## Rezoning Transportation Analysis

Petition Number	2016-075	Updated	5/24/2016
Location	Approximately 0.55 acres located on the northwest corner at the intersection of Central Avenue and Chatham Avenue.		
Staff Resource	Kory Hedrick	<a href="mailto:khedrick@charlottenc.gov">khedrick@charlottenc.gov</a>	704.432.6511

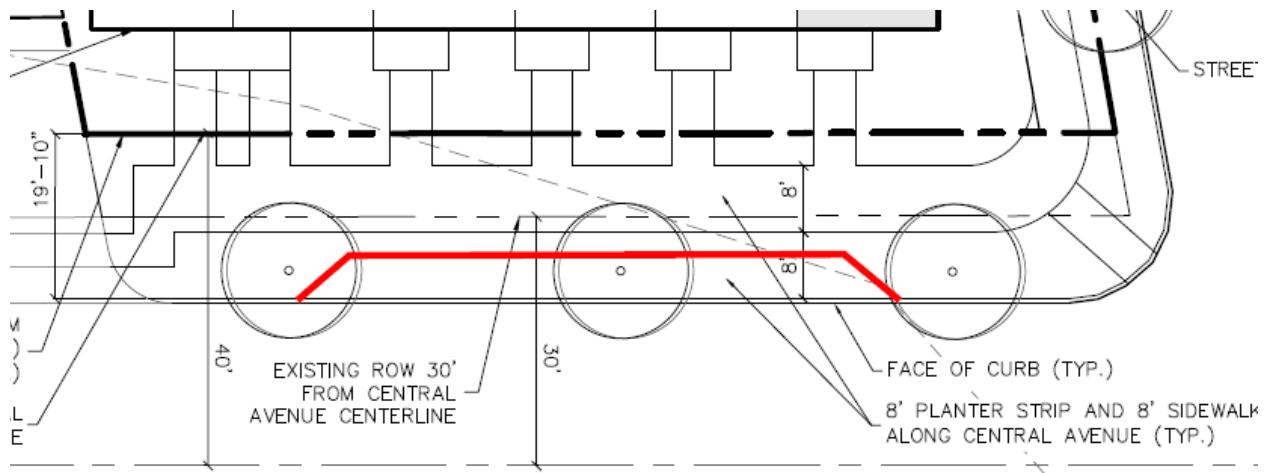
- CDOT requests that the petitioner construct on-street parking along the property frontage as generally depicted below. Based on our calculations we believe 3 parallel parking spaces can work here. This request is consistent with other rezoning requests in this area along Central Ave.
